Addendum No. C

To the contract documents for NORTH VERDEMONT ELEMENTARY SCHOOL, DSA No. 04-122168

For the SAN BERNARDINO CITY SCHOOL DISTRICT

LPA Project No.: 30899

DEMOLITION PLAN

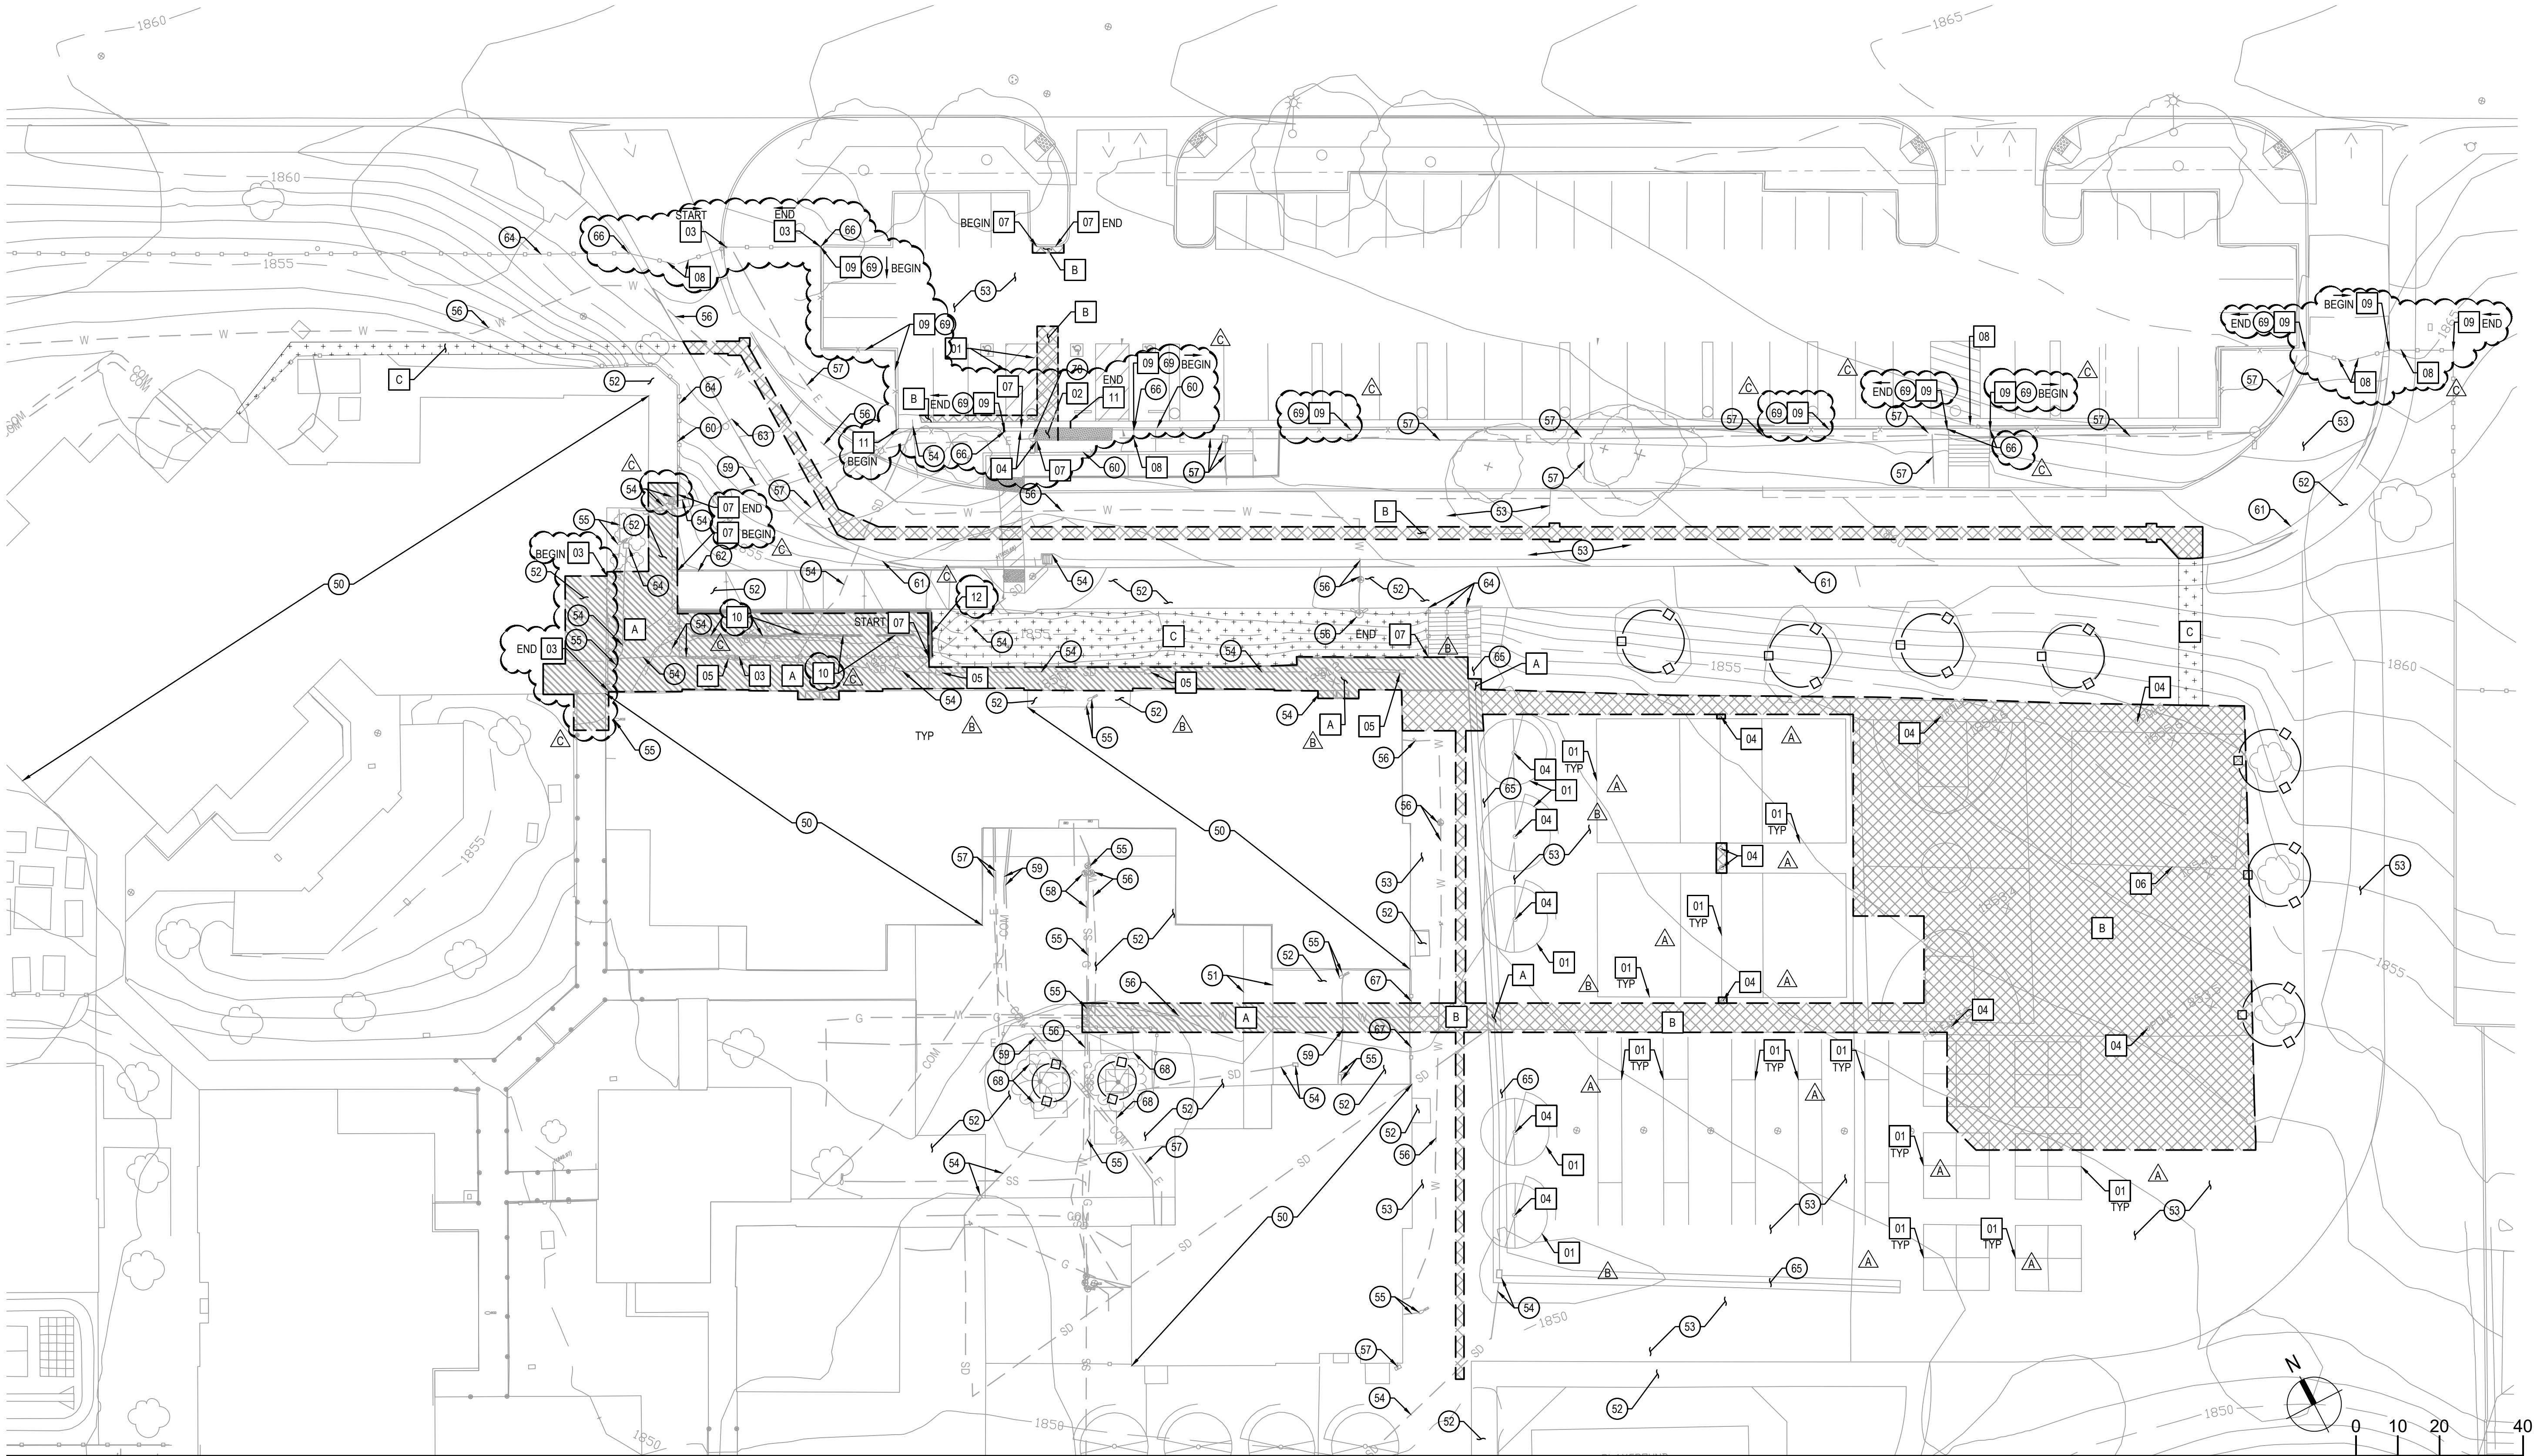
| <b>Item No. 7</b> | C0.01 – DEMOLITION PLAN<br>a) Added keynote 08 to remove existing fence gate and Aiphone Conduit at existing parking lot perimeter.<br>b) Added keynote 09 to cut existing fence mesh and pole to 42" height.<br>c) Added keynote 10 to remove existing bike rack.<br>d) Added keynote 11 to remove and replace existing gutter.<br>e) Added asphalt pavement demolition for new storm water trenching.<br>f) Added demolition scope near the accessible parking lot.<br>g) Updated demolition scope to remove existing curb and concrete pavement up to the existing retaining wall to the northwest of existing building.<br>h) Added protection notes for surrounding area to remain as is. |

- i) Added protection keynote 69 and 70.
  - j) Added demolition keynote 12 to remove existing retaining wall, but protect the footing to be reused.
  - k) Updated fence removal and concrete removal scope to west part of project site.

GRADING AND  
RECONSTRUCTION  
PLAN

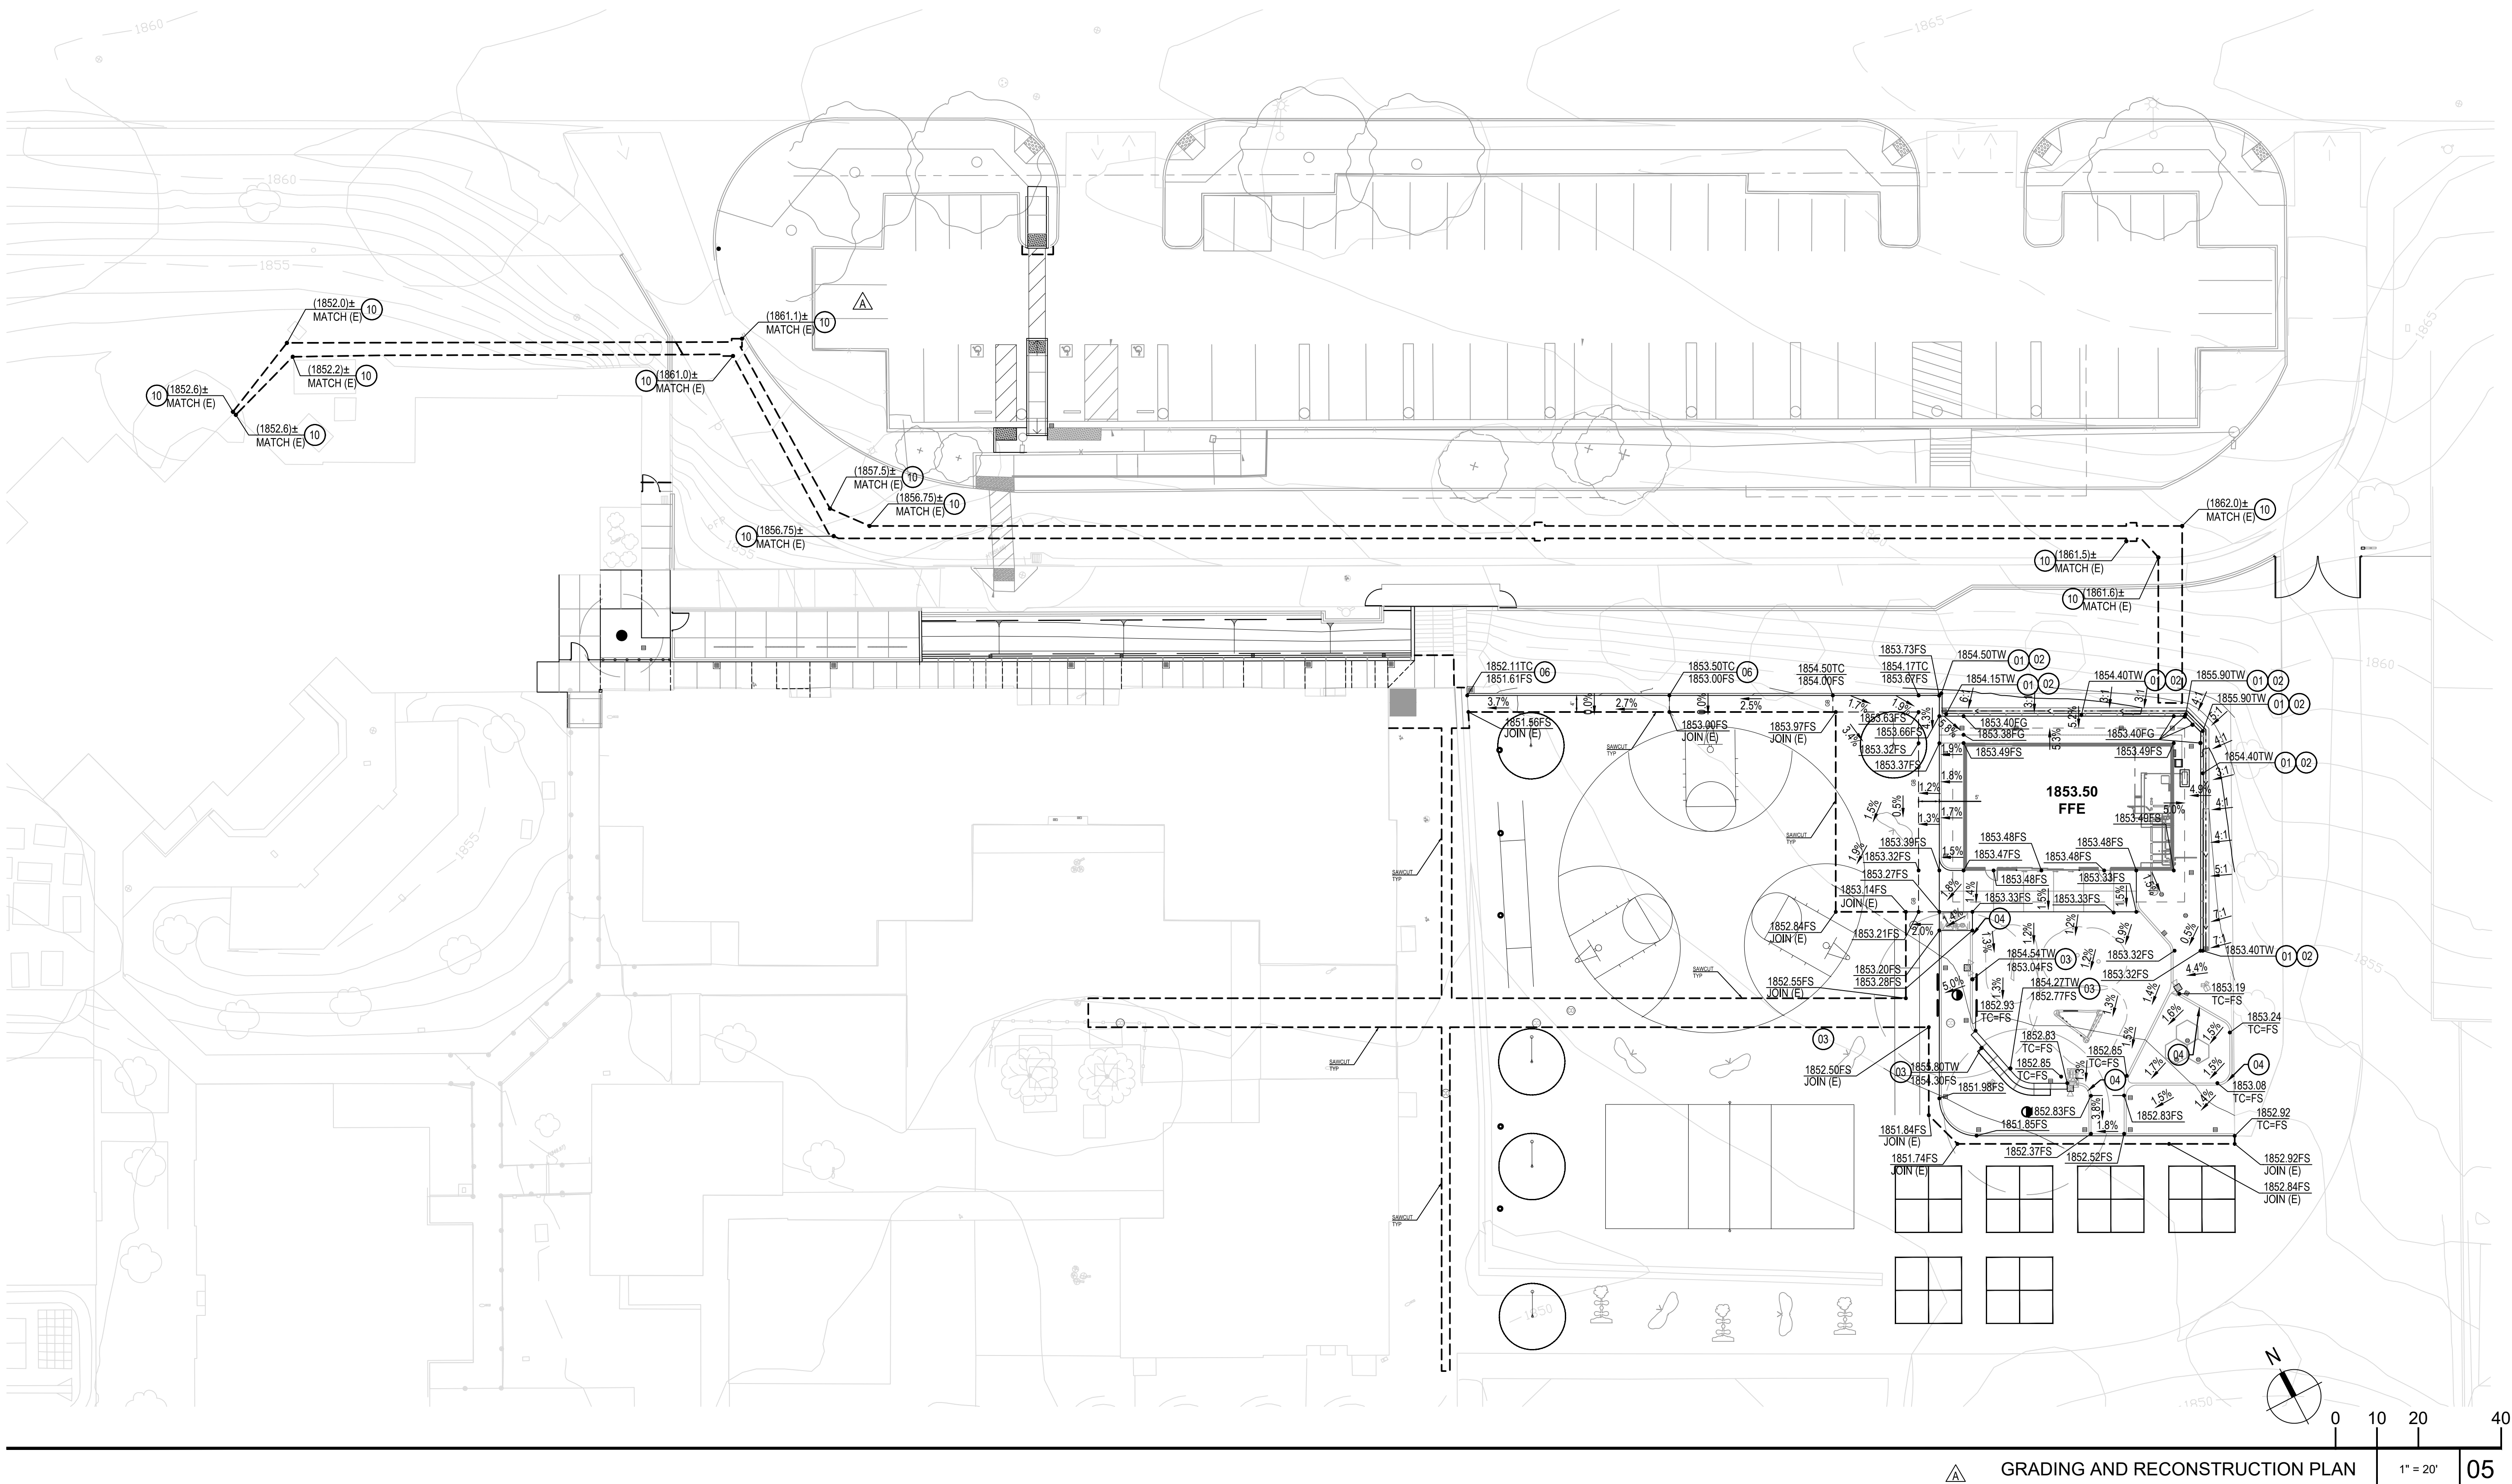
- Item No. 8**      C2.01 – GRADING AND RECONSTRUCTION PLAN
  - (a) Revised site plan design reconfiguring the planting space and surrounding grading.
  - (b) De-scoped a site ramp and handrails.

- (c) Added a sloped walk area.
  - (d) Adjusted elevated walkway grading at upper parking lot ADA stalls.
  - (e) Added top of wall elevations at added retaining wall near slope and bike enclosure.
